**GEORGETOWN-SCOTT COUNTY PLANNING COMMISSION**

**AGENDA**  
**March 8, 2018**  
**6:00 p.m.**

**BETTY YANCEY GRIFFITH TRUST PROPERTY  
PRELIMINARY SUBDIVISION PLAT  
Staff Report to the Georgetown-Scott County Planning Commission  
Postponed February 8, 2018  
March 8, 2018**

**FILE NUMBER:** PSP-2018-05

**STATISTICS**

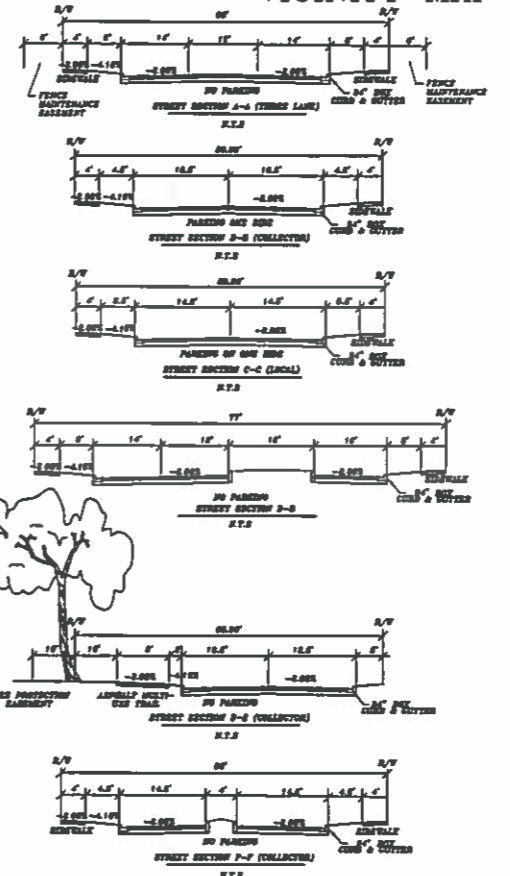
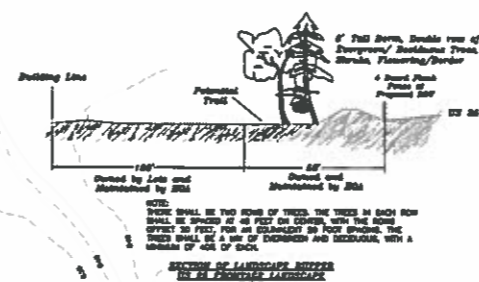
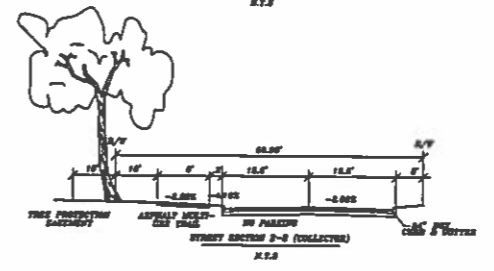
The majority of lots, roughly 70%, are in the 50'-60' lot width range. The majority of lots appear insufficiently deep to have usable back yard area. Especially along the perimeter of the site where there is a required 15' landscape buffer and where lots back up to internal tree preservation areas. The majority of lots are 110' deep. This may be sufficient to provide area for the principal structure, but leave little area for future expansion or attached decks or covered patios. There is also a large proportion of 50' wide lots. Although 50' wide lots have been approved in the past in PUDs they are not ideal in large numbers and leave a narrow buildable area and force the construction of "snout" house or houses whose garage doors are the dominate feature of the front façade.

The proposed Preliminary Subdivision Plat statistics show a minimum lot size of 5450 square feet and an average lot size of 7676 square feet. The average lot size was calculated by the applicant using some of the area in the required landscape buffer area along U.S. 25 to generate the average lot size. There is also an area of R-1C zoning on the east side of Dry Run Creek which is inaccessible due to the existing flood plain and creek. This area was also shown as open space on the Concept Plan. It is staffs opinion that the Landscape buffer areas, floodplain and planned open space areas were not intended to be used to calculate the average lot size in the development. It is also staffs opinion that a minimum lot width should be set at 55', as was done to the most recently approved R-1C PUD at the Abbey at Old Oxford in order to allow a sufficient amount of buildable area on each lot.

The subject property includes, according to the Concept Plan 122.2 acres of gross area. Of this area 17.81 acres is floodplain and zoned C-1 (Conservation). The Conservation zone is non-buildable and was set aside as open space. There is also .443 acres proposed for right-of-way dedication along US 25 and 23.412 acres proposed for right-of-way for internal subdivision streets. The net acreage is therefore calculated as  $122.2 \text{ acres} - 17.81 \text{ acres} - .443 \text{ acres} - 23.412 \text{ acres} = 80.535 \text{ acres}$ .  
 $80.535 \text{ (net acreage)} \times 4.4 \text{ (maximum net density)} = 354 \text{ lots}$ .

The road layout proposed in the subdivision is similar to what was proposed on the Concept Plan. There are two main collector roads serving the subdivision and they are intersected approximately every 250' by cross streets. There are three stub connections to the farm to the north. No connections are shown to the school property to the south. The collector streets are designed with traffic calming bulb-out features at approximately 1000 foot intervals. In between the short blocks the plan shows on street parallel parking on the collector streets. The alternative design of the street sections and the narrow median on the main feeder streets is not supported by the Planning Commission Engineer.

The proposed plan shows a driveway access across Dry Run Creek to three large lots in the area zoned R-1C PUD on the east side of the Dry Run Creek floodplain. This area was shown as open space on the zone change concept plan. A driveway across the floodplain and development of these lots in this way is not supported by staff and does not conform to the approved concept plan.

Based on the above review, the Preliminary Subdivision Plat layout has addressed some of staff concerns, but still has too many lots with insufficient width and depth. The open space provided has been encroached upon by residential lots to the degree that it does not provide community space equivalent with the increase in development densities requested.

6. Redesign roadways to meet current roadway standards. Final street design (including width, parking and intersection design) and traffic calming measures shall be approved by City and Planning Commission Engineer prior to construction plan approval.

9. "Blue-line" stream identified and inventoried in the Dry Run Plan-"Stream Protection Area" is noted as HOA #2 now but should be noted for protection and stream buffer area. Details of stream riparian buffer protection or restoration shall be provided and approved prior to construction plans approval. (cross section of width and riparian buffer as minimum).

10. Offsite drainage from area of Stonehedge must be discussed in detail. Project must account for and be evaluated to allow for drainage to pass in the event that upstream sinkholes are "plugged". Still have concerns about how pass-thru will be routed and with lots being built through here. 9/1/17 Karst exploration Report provides warnings about this area and there are "dips" in the bedrock (from the GPR & borings) that are suspicious. **Not enough information is currently available to support residential structures being located in this area.**

12. Identify all depressed and Environmentally Sensitive Areas on site on the preliminary subdivision plat. Besides the area by US 25, other "depression" were noted during our site visit and show up as anomalies on your topo and are in a line paralleling the southern property line. Note on preliminary that these areas must be avoided or studied and mitigated if approved by PC at the meeting or after evaluation has been documented. **Additional "depressed" areas were observed during site visit on 2/1/18 along the "drain" to the north-east (lots 33-80) and around the tree area of lots (216-218 thru 164-165).**

**SITE PLAN**  
 SHEET NUMBER  
**C2-00**

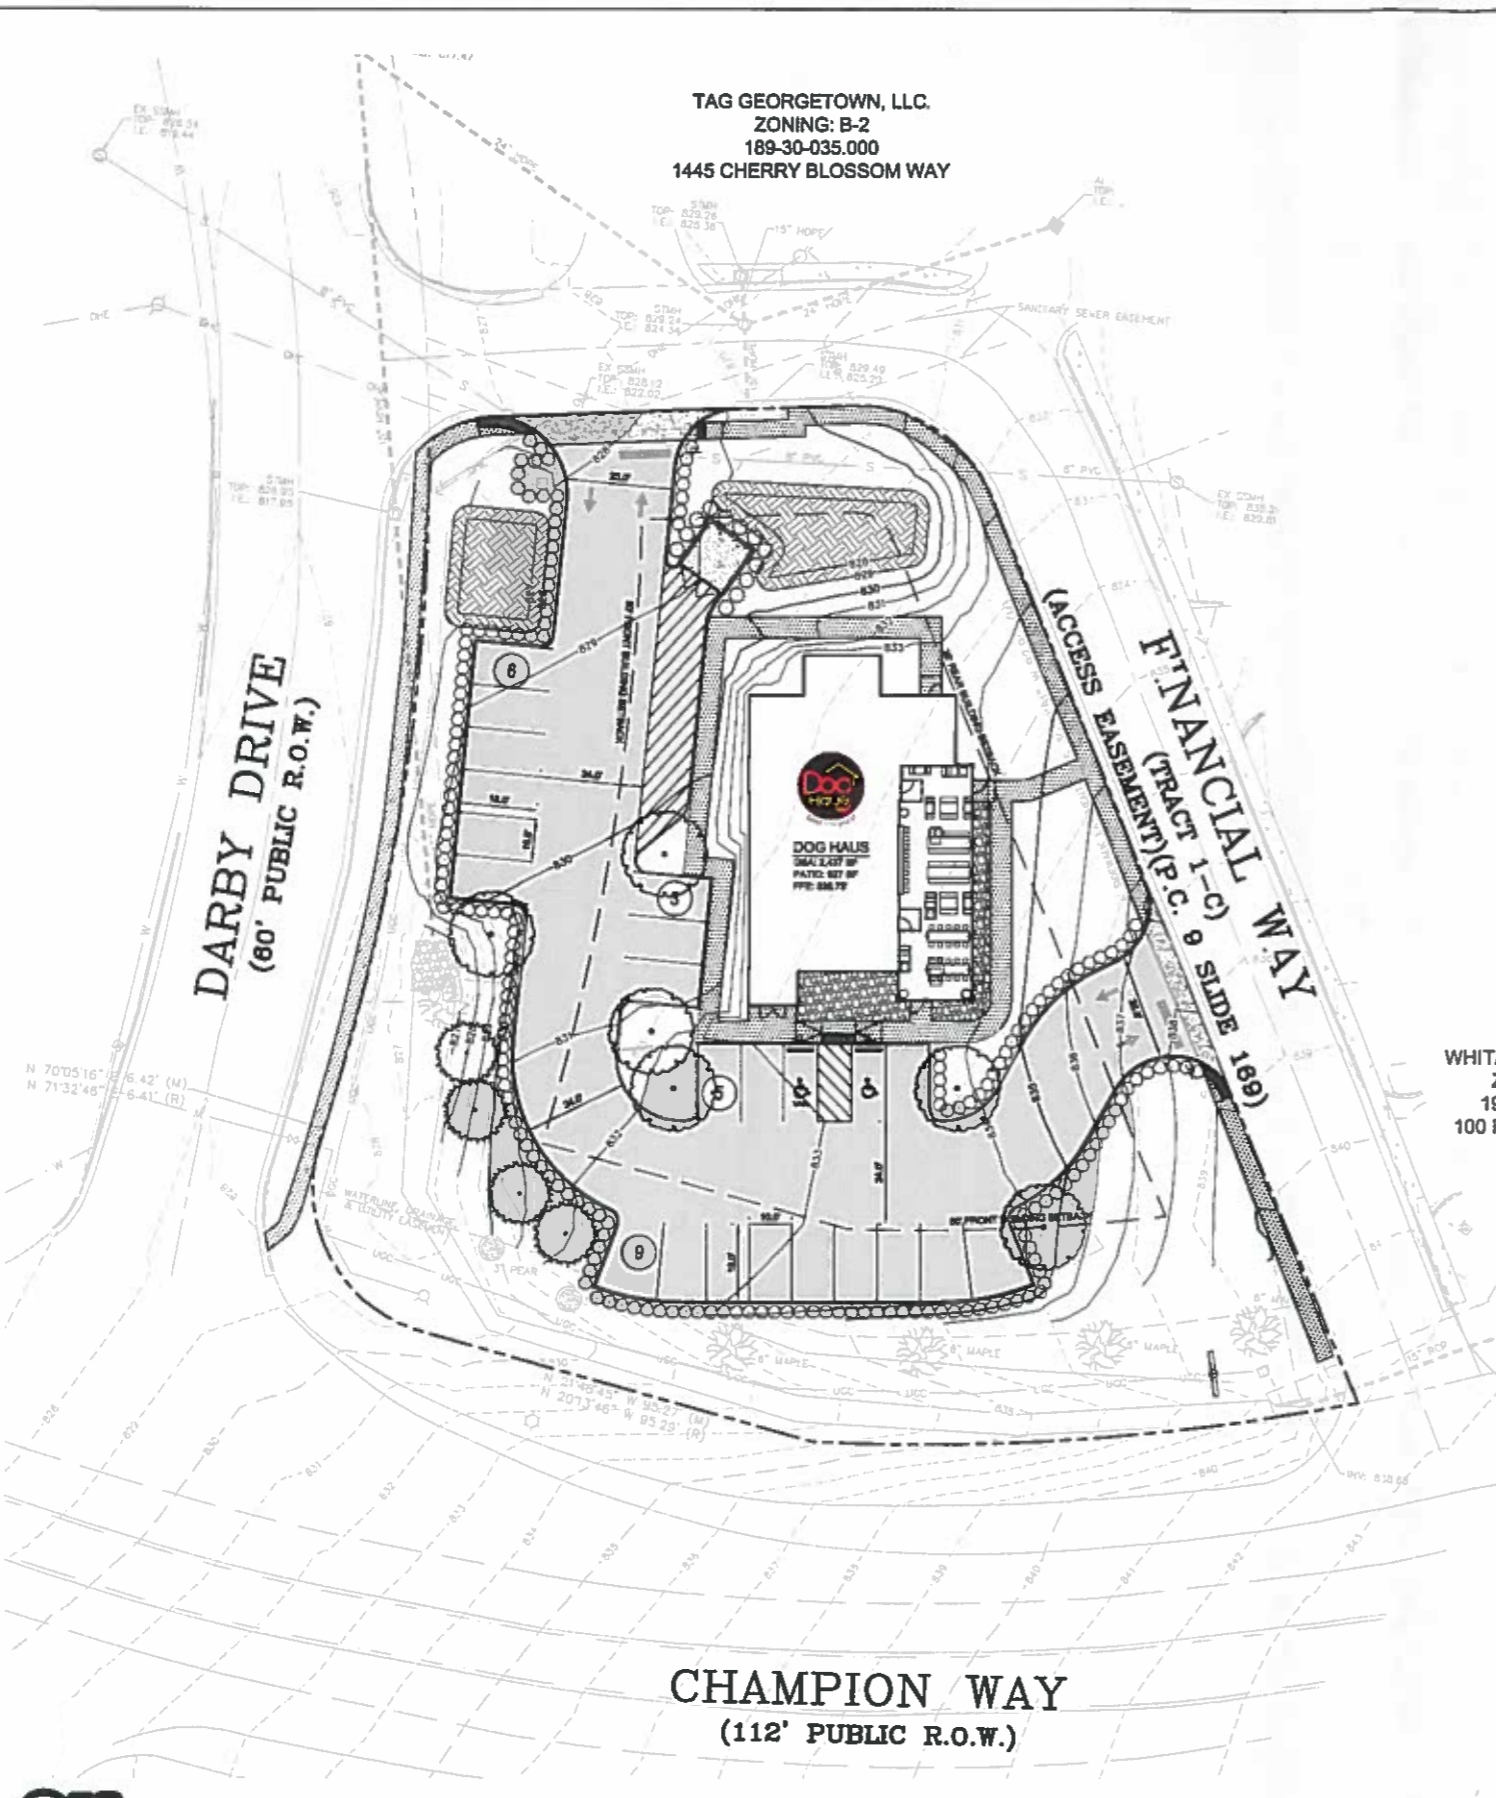
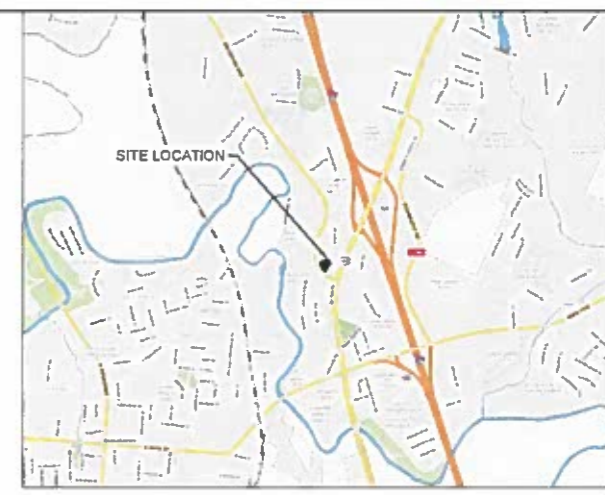
The Preliminary Development Plan shows a 50-foot building line along Darby Drive. This should be adjusted to a 25-foot building line on the Final Development Plan. The proposed building location for the Project Site meets the 25-foot building setback requirements. The footprint of the proposed structure will cover 3,364 square feet, or 8% of the lot area, which is under the 50% maximum building ground coverage allowed.

*Driveways & Access:* There are two new entrances proposed on Financial Way. The southern entrance along Financial Way does not meet the minimum separation requirement and a variance will be required if the Preliminary Development Plan is approved as shown. The Subdivision and Development Regulations state "accesses on opposing sides of the street shall be either opposite each other (+/- 5.0 feet) or at least 100 feet from center line to center line". The proposed access is approximately 60-feet from the southern entrance of Whitaker Bank and 65-feet from the northern entrance of Whitaker Bank. The Planning Commission Engineer recommended that the entrance should either be opposite the southern entrance of Whitaker Bank and be a right-in right-out only, or that the proposed entrance should split the two existing entrances for Whitaker Bank. The Applicant has proposed the latter.

The Applicant has proposed 13,185-square feet of Vehicular Use Area on the Project Site, which requires 1,319-square feet of landscaped area. The Applicant has proposed 1,354-square feet of landscaped area, but did not provide landscape islands. However, due to the configuration of the VUA Staff feels the interior landscaping area shown is sufficient. The Applicant is required to have 5 interior trees, and is showing 6.

1. Variance to reduce the minimum separation requirement for accesses on non-residential streets from 100 feet to 60 feet.
